Product Change Notification					Change production location of div. types		
owner	creation date	release date	released by	change order	rev	page	D10-101-490
sariogar	13.07.2026	13.07.2026	gassmael		B	1 of 2

M1733 - Change of Country of Origin - PG 05

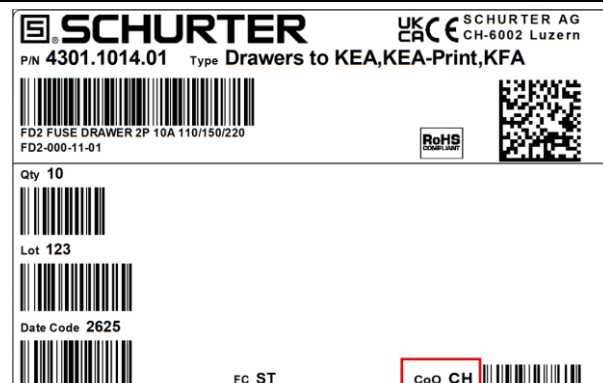
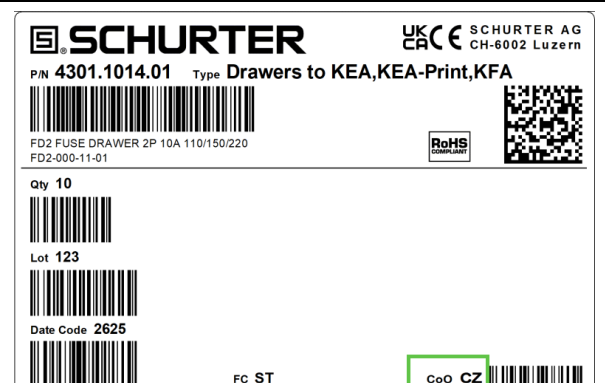
Current Packaging label country of origin Switzerland	New Packaging label production site Czech Republic
